DEVELOPMENT APPLICATION ASSESSMENT REPORT

Application Number:	DA2019/1260
----------------------------	-------------

Responsible Officer:	Renee Ezzy
Land to be developed (Address):	Lot 33 DP 8394, 29 North Avalon Road AVALON BEACH NSW 2107 Lot 32 DP 8394, 27 North Avalon Road AVALON BEACH NSW 2107
Proposed Development:	Demolition works and construction of a Seniors Housing development comprising 10 self contained dwellings and site consolidation
Zoning:	R2 Low Density Residential R2 Low Density Residential
Development Permissible:	Yes, under SEPP Housing for Seniors or People with a Disability (HSPD) 2004
Existing Use Rights:	No
Consent Authority:	Northern Beaches Council
Delegation Level:	NBLPP
Land and Environment Court Action:	Yes
Owner:	Armada Avalon Pty Ltd
Applicant:	Armada Avalon Pty Ltd

Figure - First Floor Plan (elevated walkway). Source: Architectural Plans by Enviro Studio

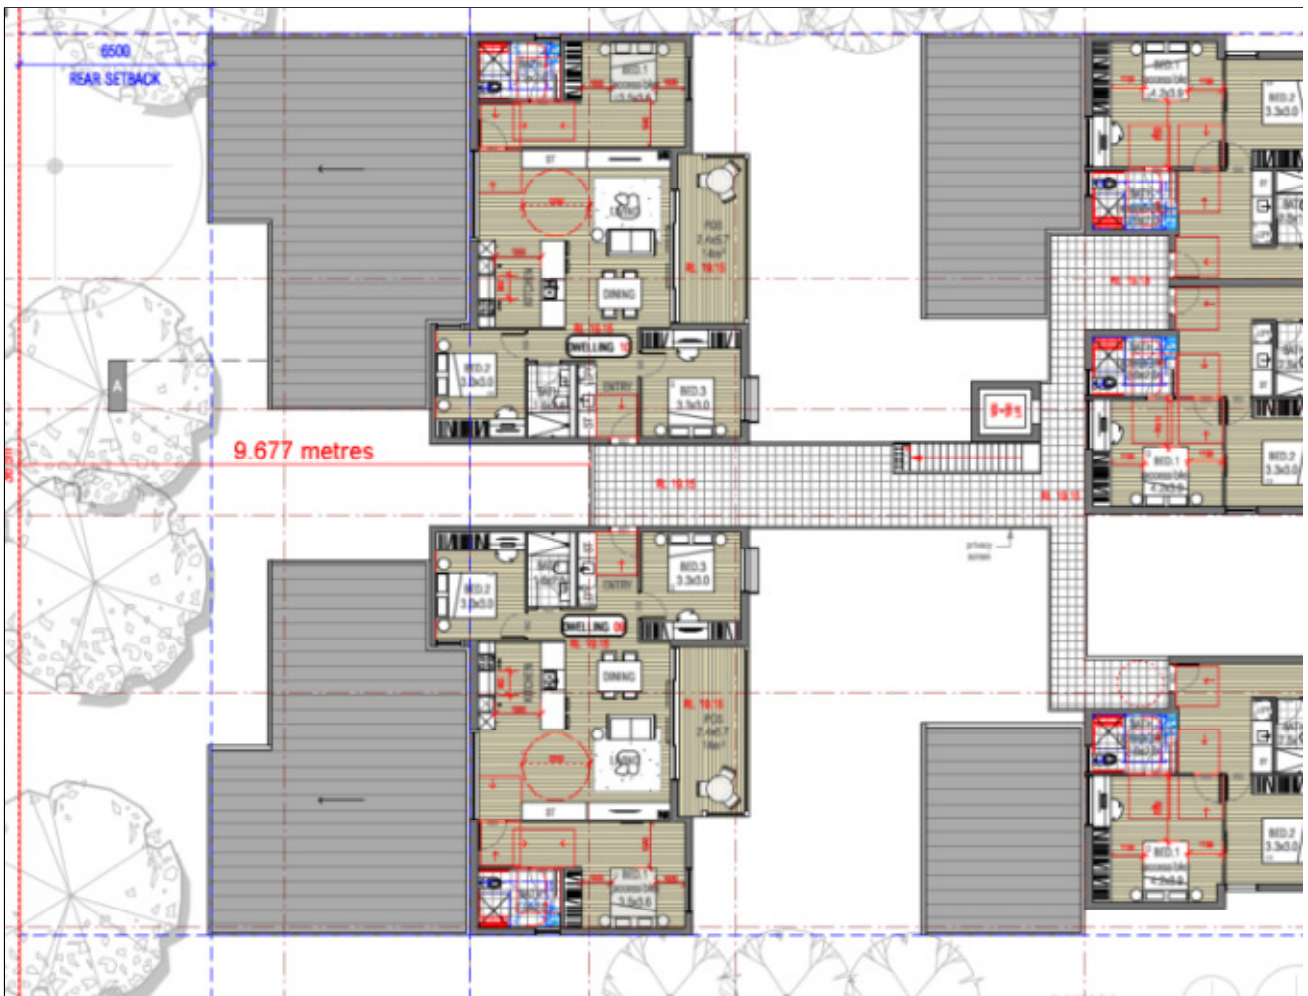
The proposed development which incorporates ten (10) dwellings on the site includes five dwellings at first floor level which are connected by a central elevated walkway.
